Subject: Crystal River Unit 3
Docket No. 50-302
Operating License No. DPR-72
Environmental Protection Agency 316 Study

NOTES OF CONFERENCE
THIRD QUARTERLY PROGRESS MEETING
FLORIDA POWER CORPORATION

Enclosed is a copy of the Notes of Conference from the Third Quarterly Progress Meeting for the Crystal River 316 Study held in St. Petersburg on May 3, 1984.

Survey #1

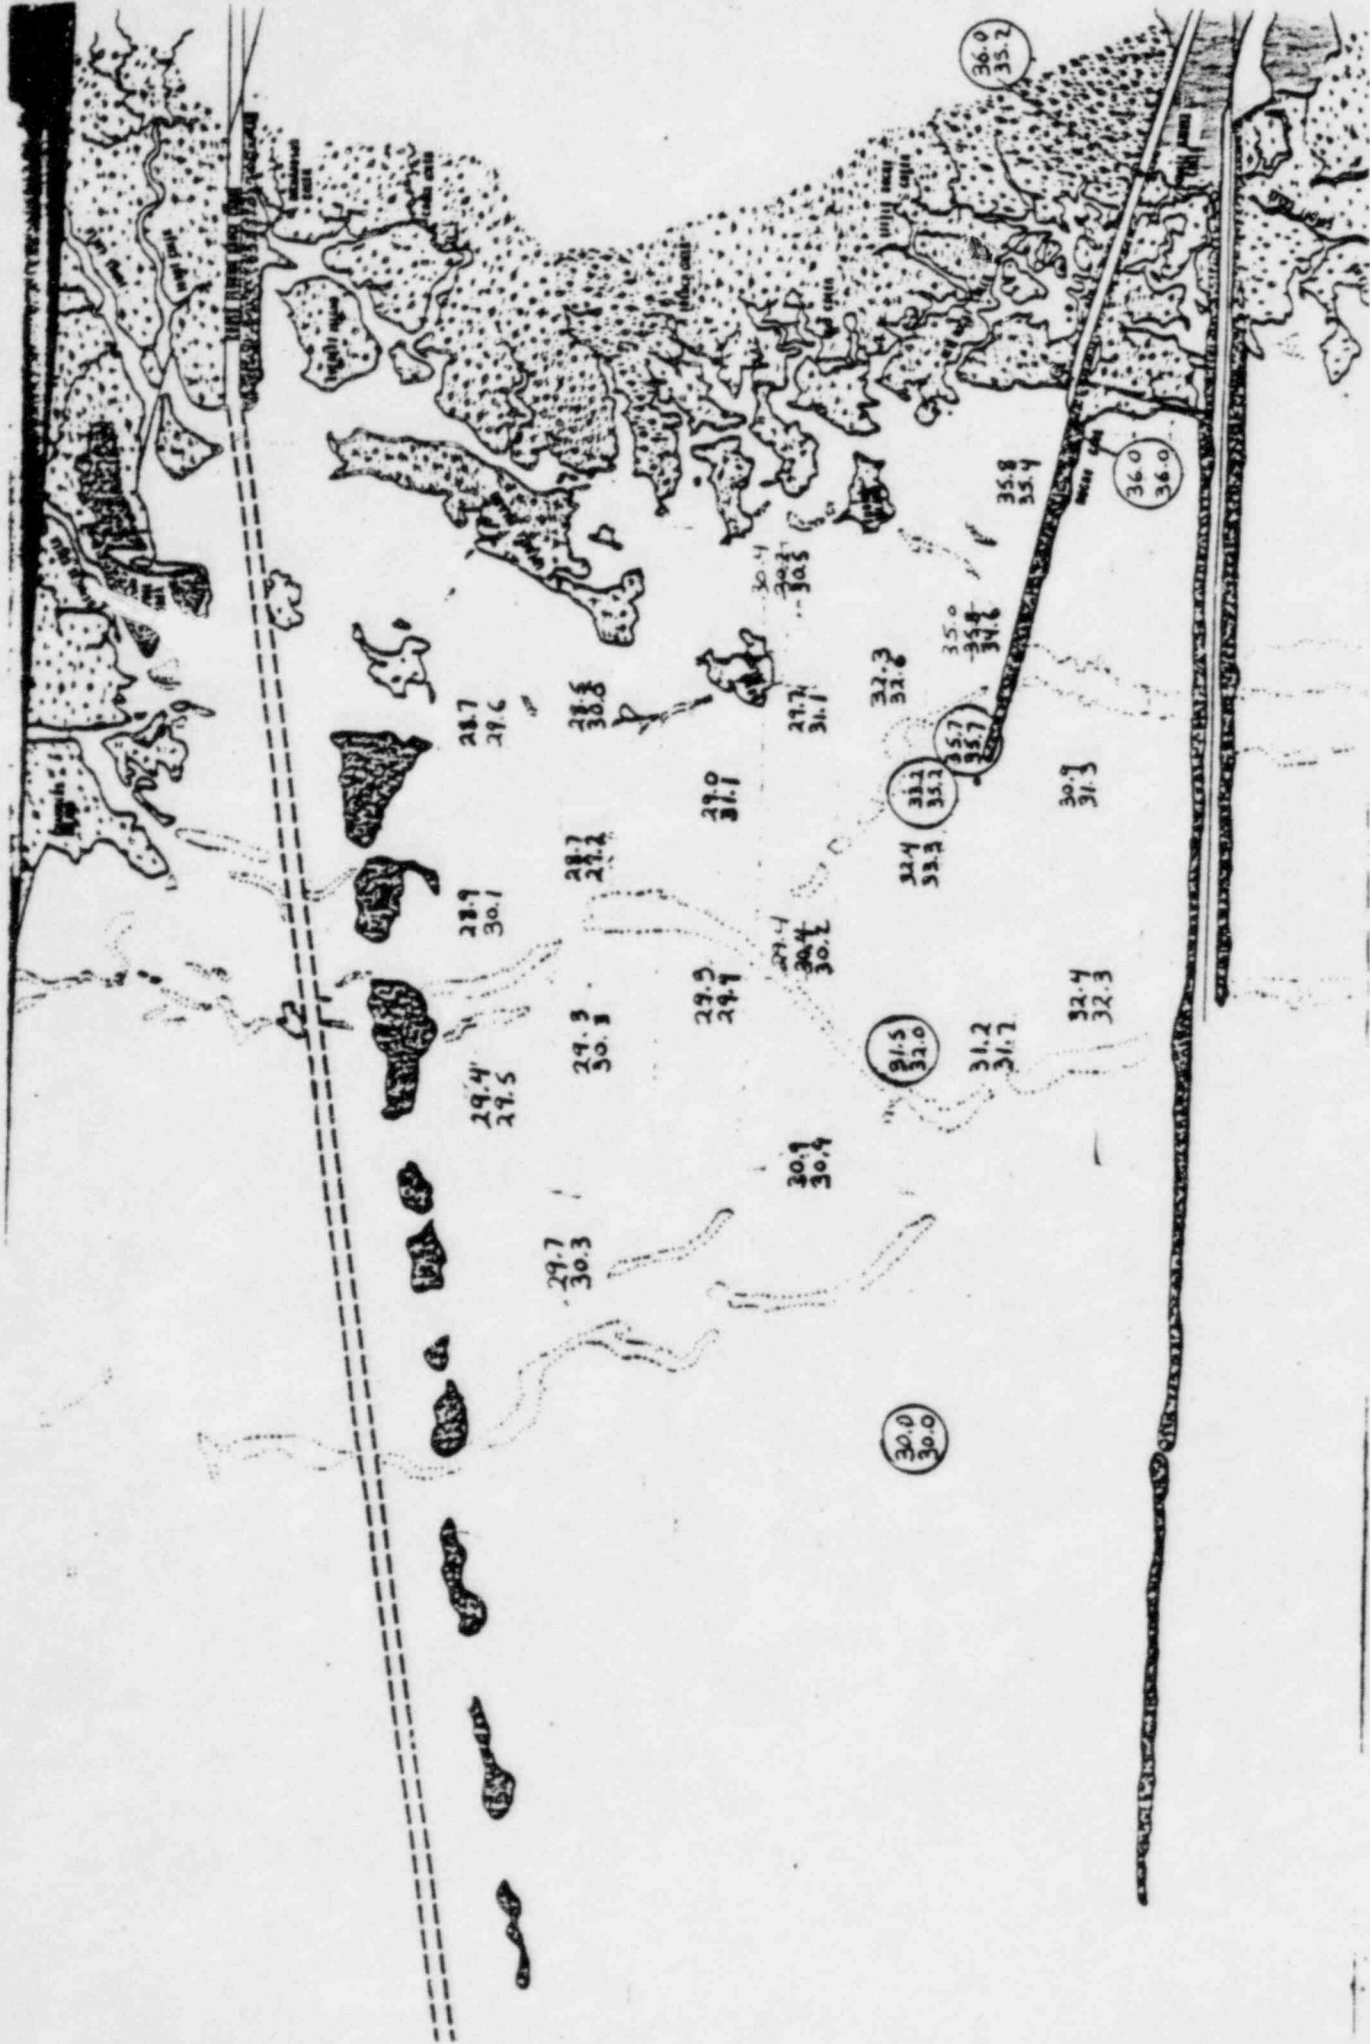
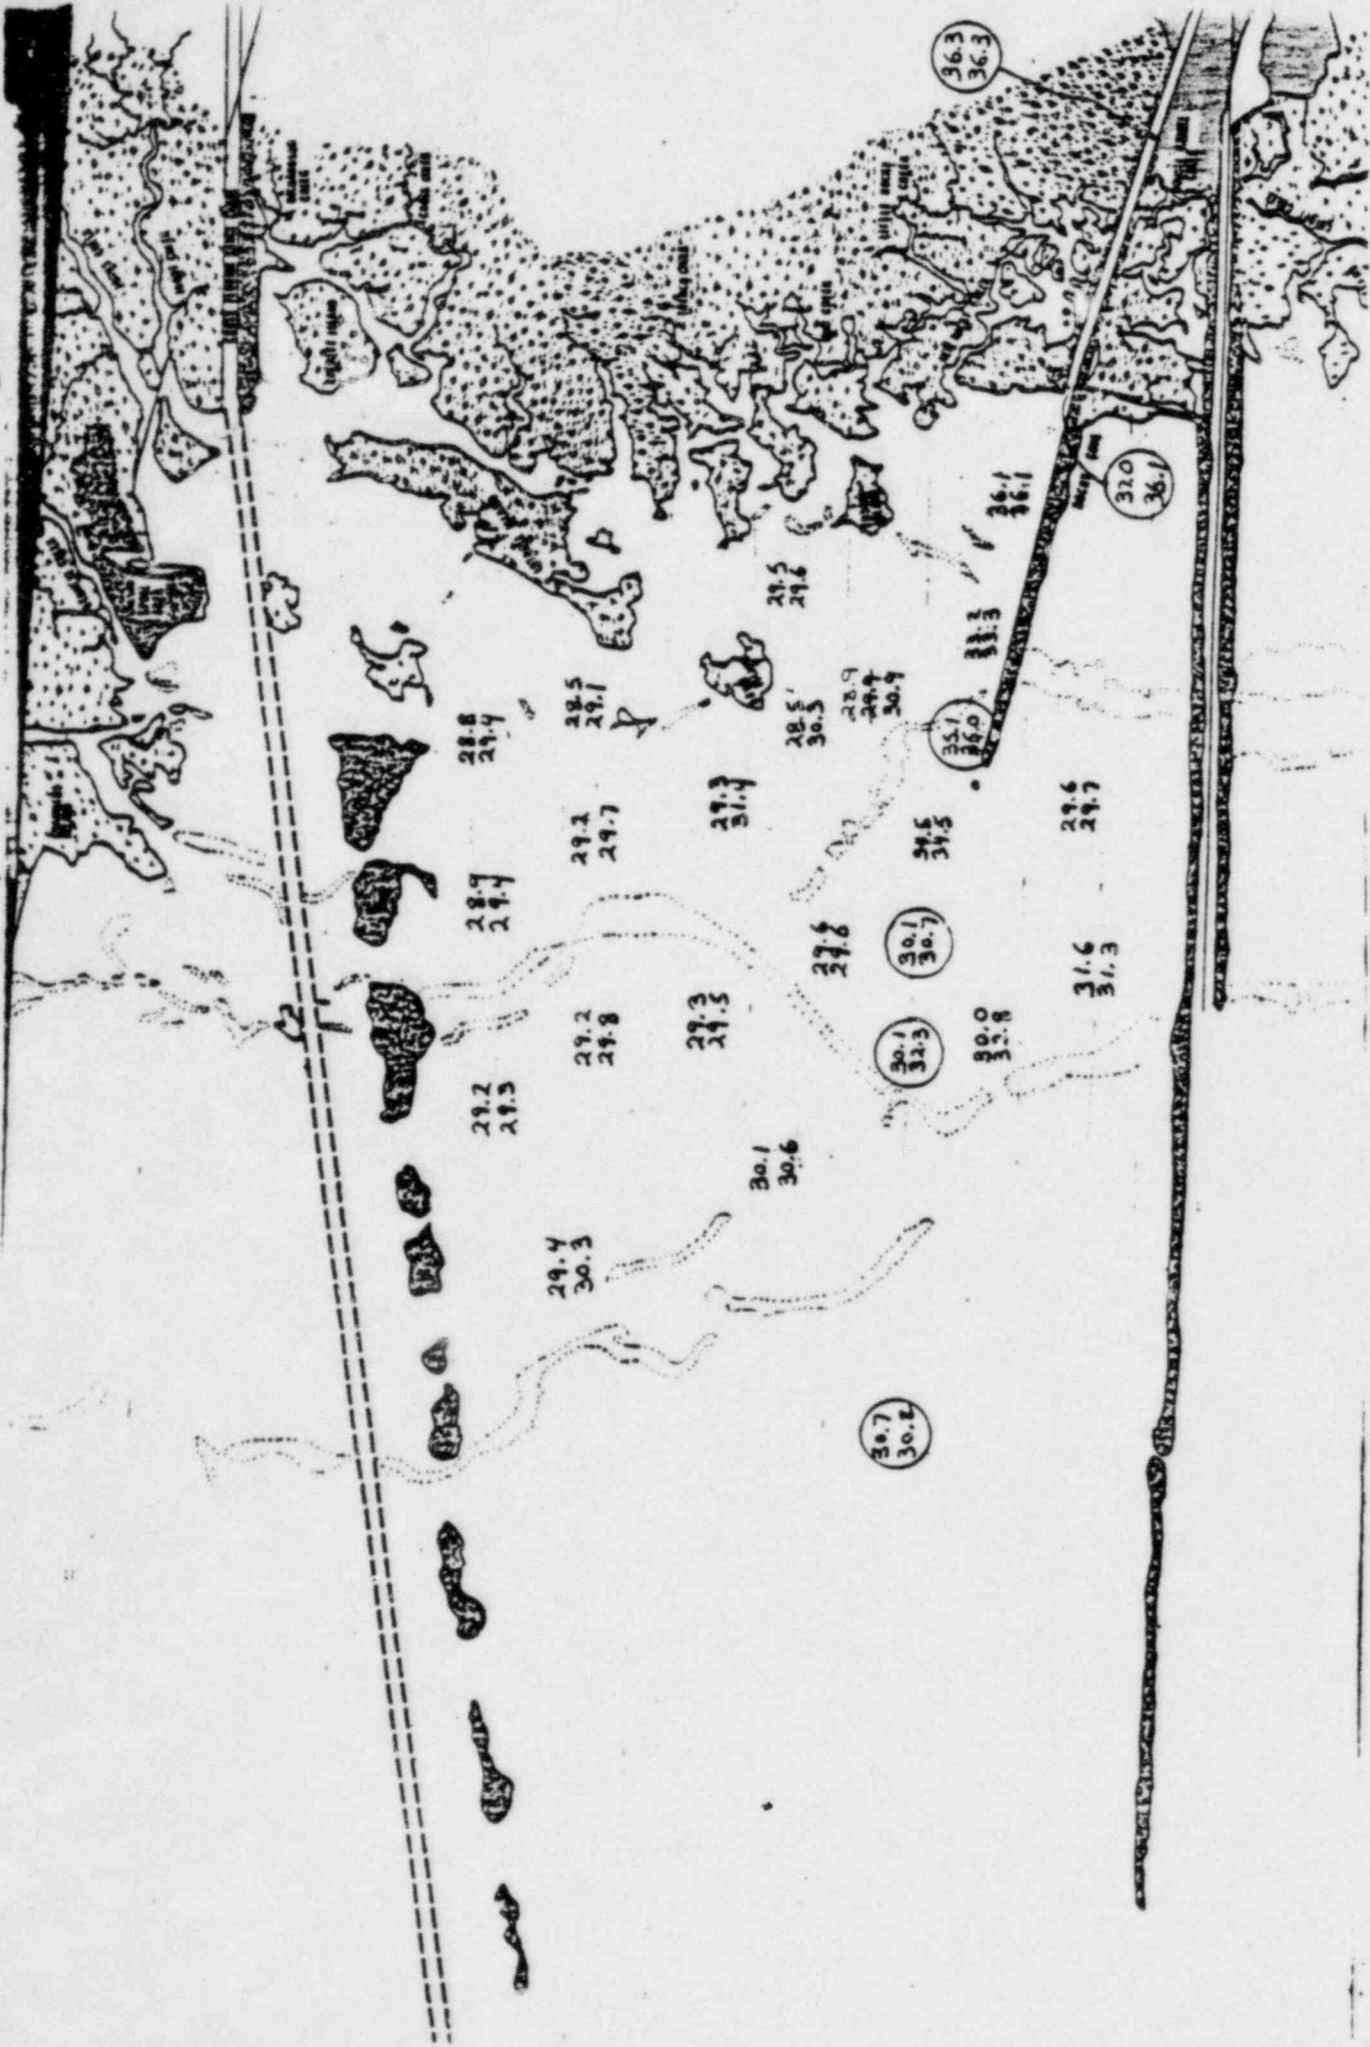
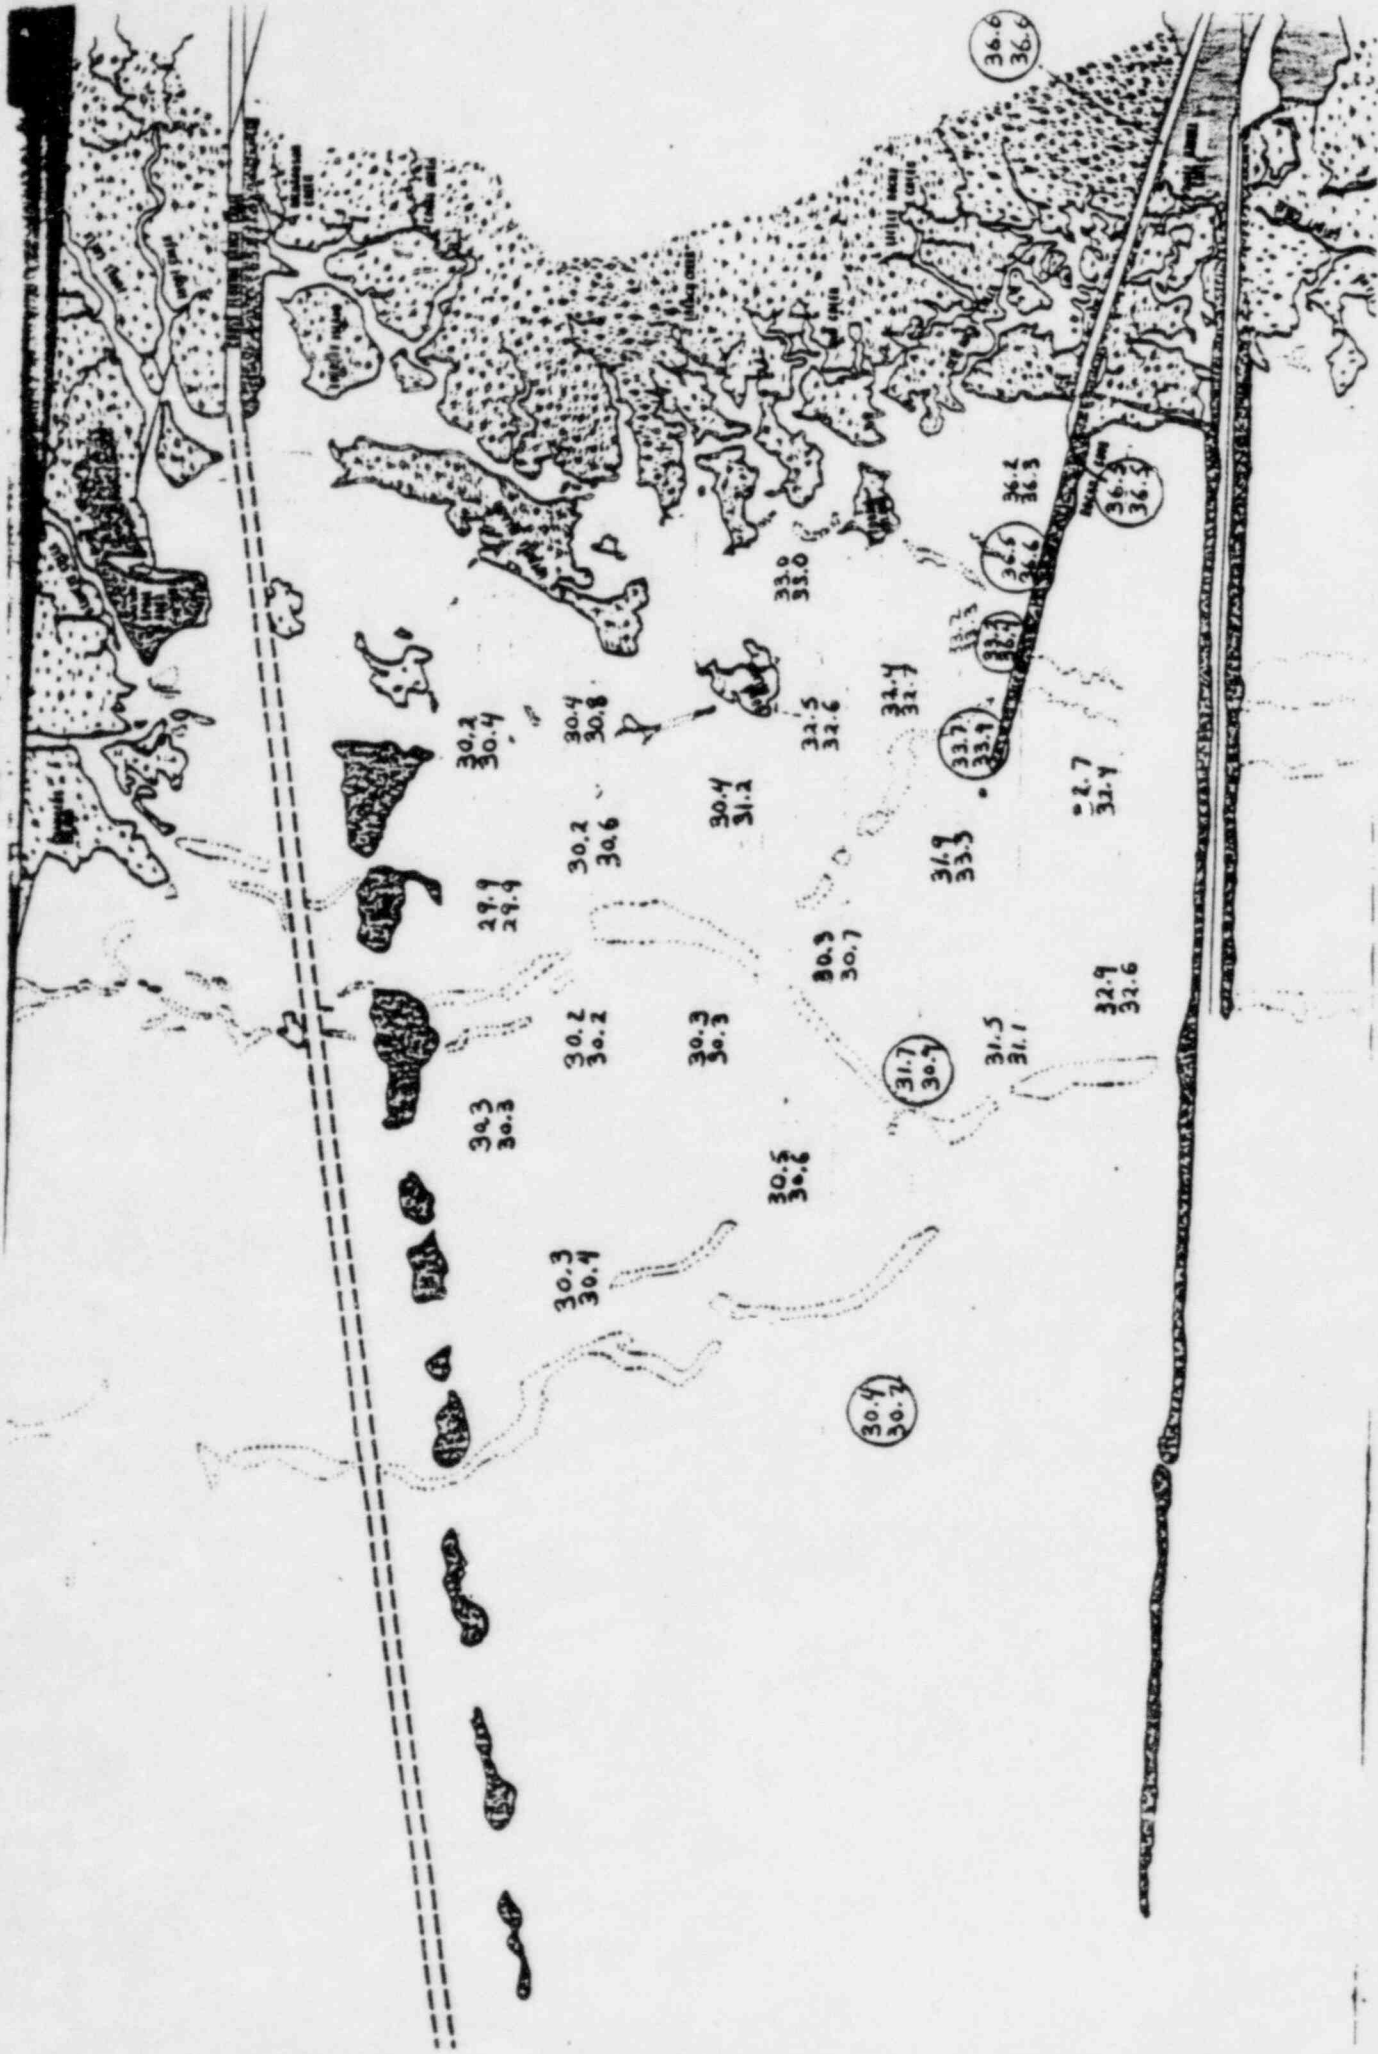
The August and January plume delineation surveys were discussed. Stations were marked by buoys but did vary from one circuit to the next based on tidal conditions, problems locating stations at night, etc. Loran was used to locate stations not at buoys. A map should be provided showing station locations and depths.

There are a few errors in the existing data tables (salt marsh, temperature, entrainment). Corrections were made available at the meeting and marked pages will be sent out shortly. C. Kaplan believes there are still some outliers in the temperature tables and would like to have more information regarding these data including: tidal phase and tide level sampled, station depth, time of tide window, and time of sampling by station.

- Revised tables of June temperature and conductivity. These tables have been changed to reflect a 90 minute, rather than a 2 hour, tide window and to correct incorrectly specified times for maximum tide.
- July, 1984, temperatures by week.
- Juncus marsh data for October, 1983.
- Entrainment densities for July 21, August 31 (2), September 14, and September 27.
- Fourteen figures showing temperatures monitored in August and January. Also, please note that a few uncircled temperatures have been found to represent single readings in contrast to the absolute statement on Page 4-1 of the Quarterly Report, however, they remain uncircled to distinguish the readings from ones taken by the "chase" boat.
